**PROJECT 541
NEW ANIMAL SHELTER
PHASE 3 - FENCING
JULY 21, 2026**

ADDENDUM NO. 1

Subject: Animal Shelter Date: 7/21/21 Sheet: 1 of: 1

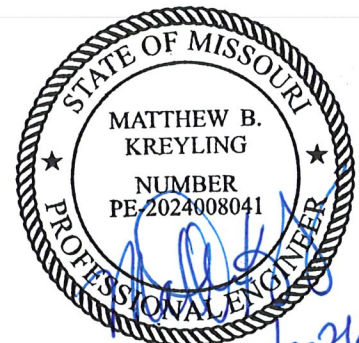
1. There is in-floor hydronic heating installed in the kennel area. No drilling or anchoring to the interior floor will be allowed. See the attached detail for anchorage configurations for the interior kennel panels.
2. The interior kennel gates will be full width (4 feet) for each kennel.
3. All line posts to be 2-inch diameter, 13-gauge galvanized material. Corner posts should be a minimum of one size larger. Kennel framing to be same material as line posts.
4. All chain link fence fabric shall be a minimum of 9-gauge galvanized material.
5. All kennel construction shall be anchored to the existing block walls utilizing Hilti HIT-HY 270 epoxy with HIT-SC screen tubes, or an equivalent anchoring system.
6. Include a copy of this addendum and acknowledge all addenda on the itemized bid form when submitting your bid.
7. The Bid Date remains the same.
